产 品 外 形 图

PRODUCT APPEARANCE DRAWING

MODEL NO.	PT10MV
DRAWING NO.	XHD-WI-PT10

产品名称 Product Name:	∅10mm塑封式碳膜微调电阻器
型号 Model No:	PT-10系列

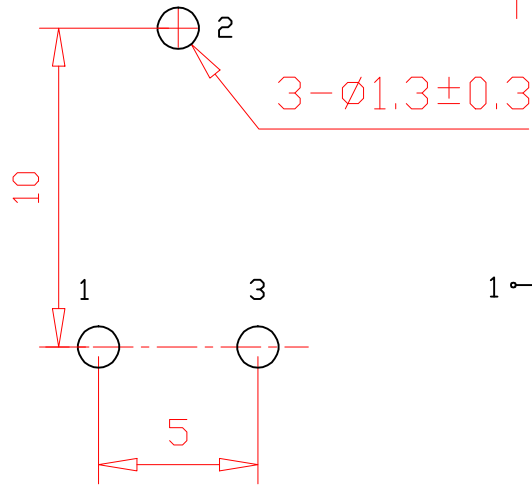
工程变更 1 原公差10+0.5改为10-11.5

工程变更 2 未注公差 0-10MM ±0.3MM

工程变更 3 未注公差 10-60MM ±0.5MM
